Your Ref: 10.2017.661.1 Our Ref: D17/4624 DA17121310830 BS

Integrated Development for 1//201626, 2//542178, 1//780242, 2//818403, 1//520063 & 7020//1113431 - Ewingsdale Road, 364, 394 & 412 Ewingsdale Road & Melaleuca Drive Byron Bay

Figure 1: Myotis macropus records from OEH Bionet Atlas.

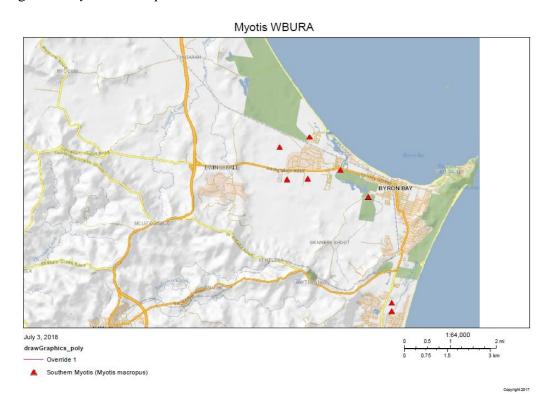
The Threatened Species Management Plan (TSMP) restricts its considerations to 13 species which have been recorded at the site. It omits to consider the threatened Southern Myotis or fishing bat *Myotis macropus* which is recorded from 2 locations in the WBURA, and which is likely to forage along the main drain (see Figure 1). By limiting its scope to threatened species recorded at the WBURA site, the threatened estuarine wading birds of Belongil Creek and its near vicinity are omitted from consideration. Appendix A lists the 64 threatened fauna species recorded from a 10km by 10km area with the WBURA at its centre, and some of these species are likely to occur at times on the WBURA site, but are not considered *e.g.* Pale-vented Bush-hen, Common Planigale.
